Technical Bulletin

Bulletin Number: 461 Revision Number: R-01

SUBJECT: COIN CUP FILLER PLATE

MODELS AFFECTED: All Circular Venders Built Prior To 0001-6439CV With The Plastic Coin Cup.

Coin Cup Filler Plate
432,010,84x.x3

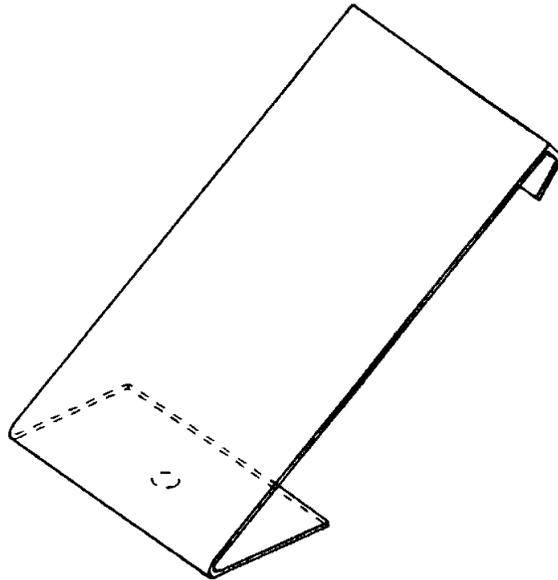
REASON: To provide a kit to reduce the depth of the plastic coin cup.

ORDER: 432,016,10x.x4 COIN CUP FILLER PLATE KIT
